DRESDEN NUCLEAR POWER STATION

UNIT 2

AMENDMENT NO. 2

ANSWERS TO AEC QUESTIONS

Figure II-2-1. Block Diagram - Single Cycle, Forced Circulation BWR

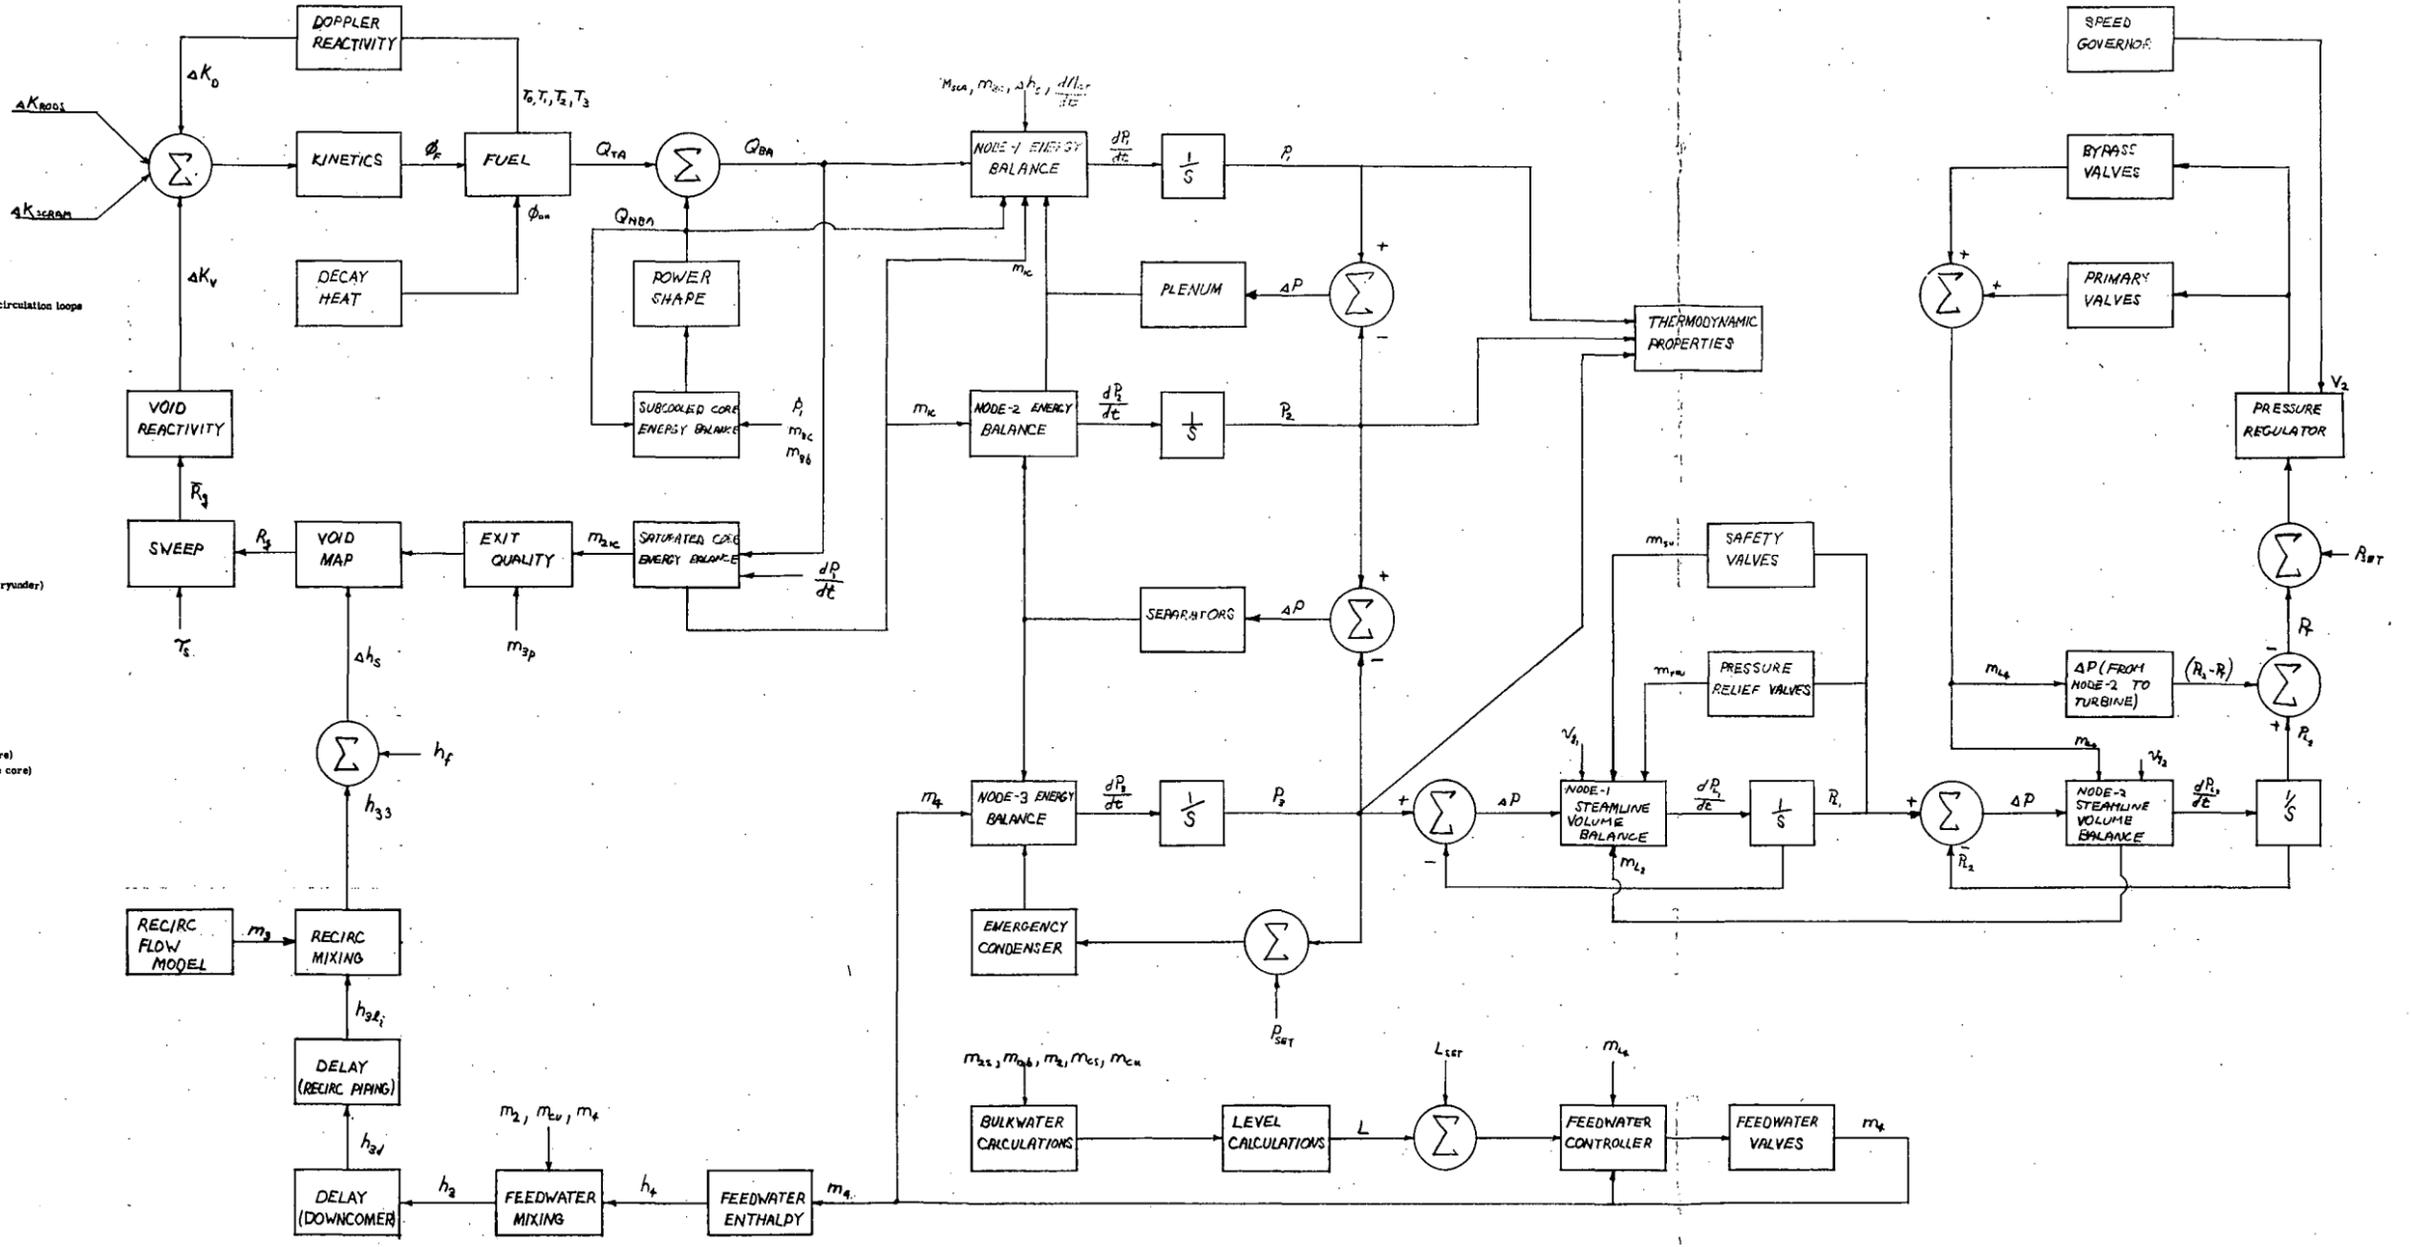
2. We understand that some significant amount of analytical work is being performed to evaluate and analyze the characteristics and stability of the reactor nuclear-thermal-hydraulic system. A description of this analysis should be provided including the parameters that are considered and the manner in which the results of this analysis are related to safe operation of the facility. If the stability analysis includes a margin of stability, or threshold of instability, provide a discussion of the basis for selection of such a margin. Define "strong negative reactivity feedback," "severe transient conditions," and "requirements for over-all plant nuclear-hydrodynamic stability" as related to the above in numerical terms if possible.

The block diagram of Figure II-2-1 indicates the extensiveness of the simulation of a BWR. It also indicates the parameters considered in the analysis. Many of the blocks are extensive systems by themselves. For example, the recirculation flow model is shown in expanded block diagram form in Figure II-2-2. The equations describing the processes are, in general, non-linear, coupled differential equations, approximately 100 in number. There are approximately an equal number of algebraic equations. In the complete model, the various processes and control systems are interlinked and although each process and control system may be stable when analyzed singly, it is necessary to examine the stability of the overall system. Final settings of control systems are therefore made on the plant model. With this complete "plant," all potential disturbances pertaining to safety, transient response, and stability can be investigated.

Figure III-2-1. Consequences of Rod Drop Accidents

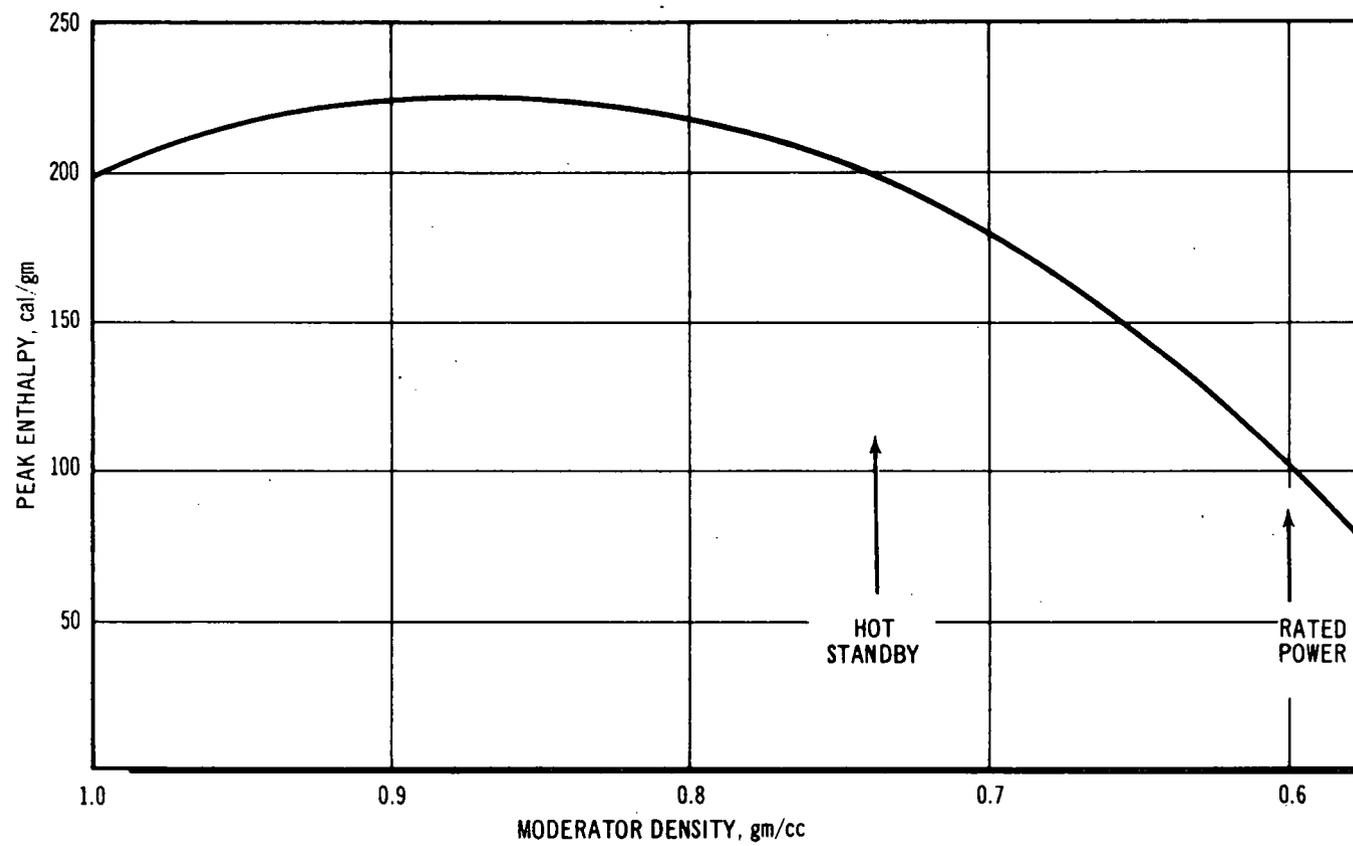
15. Discuss the manner in which Figure III-2-1 in Amendment 2 can be interpreted to include the case of a control rod drop at rated power. Discuss the effects of control rod worth, operating temperature and the Doppler coefficient at the higher temperature on this curve. Include an interpretation of the meaning of peak enthalpy.

Figure III-2-1 shows the results of a parameter study where the effects of reactor power and moderator density were investigated for a rod drop accident where the total worth of the control rod involved was the maximum ($0.025 \Delta k$). The insertion rate was a $0.025 \Delta k/\text{sec}$ equivalent ramp for the 5 ft/sec rod drop. The initial power density was $10^{-6} \times$ rated power. This power level is highly conservative since the physical case will be several decades higher in power level.

The trends shown in Figure III-2-1 clearly indicate that the hot standby condition is worse than any full power or partial power condition as the starting point for an excursion accident.

Figure III-2-1 of Amendment 2 of the Plant Design and Analysis Report is intended to show the variation in the peak fuel enthalpy (heat content) which exists in the core following a 0.025 Δk rod drop accident as a function of the initial moderator density. The moderator density is chosen as a convenient variable to indicate the state of the reactor.

The maximum rod worth of $0.025 \Delta k$ was used for the entire range of reactor states shown in Figure III-2-1 of Amendment 2. The constraints of thermal limits and reduced number of rods in the core at operating power, however, will preclude rod worths of this magnitude existing in the core at power. Therefore, the maximum peak fuel enthalpy at power, resulting from the drop of a rod of less worth, will be less than that shown in Figure III-2-1. The trends of peak enthalpy as a function of rod worths below the $0.025 \Delta k$ maximum may be seen from Figure 62 in the Dresden Unit 2 Plant Design and Analysis Report, Volume 2.
